## **IMPORTANT PRODUCT NOTICE**

Reference: Padmount switchgear maintenance advisory

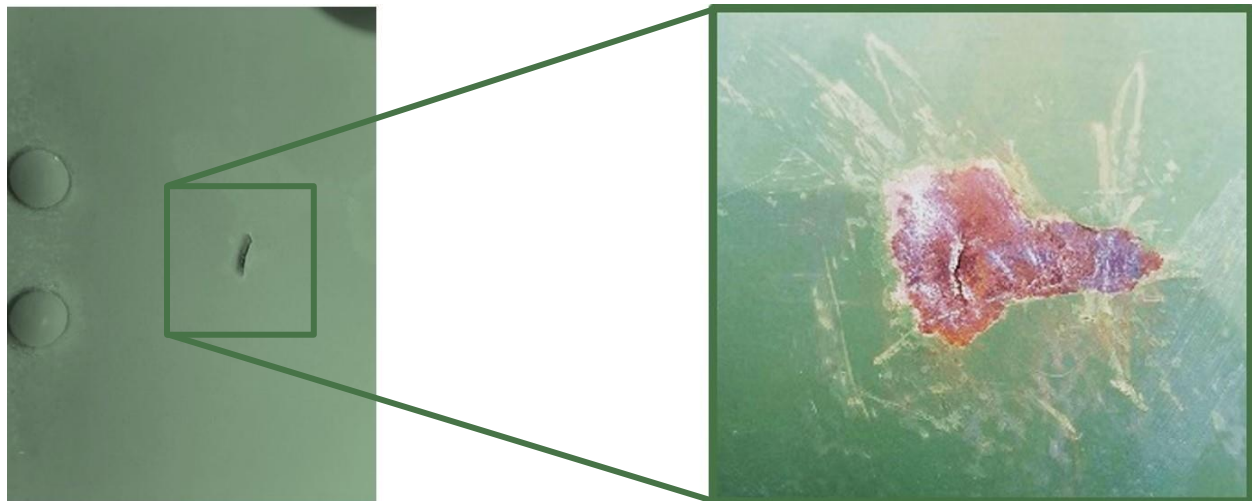
Eaton further recommends a close visual inspection of tank covers for fluid-filled padmount switchgear. The tank covers must be free of chipped paint or corrosion. If chipped paint or corrosion is found the area must be scraped or brushed to remove loose paint to expose cracks or holes in the cover. If a crack or hole is found, the switchgear must be immediately de-energized and appropriate actions taken to replace the cover and verify the dielectric fluid as indicated above. Cracked or chipped paint on the cover indicate high stress. Even if no hole or crack is present, covers exhibiting cracked or chipped paint should be replaced.
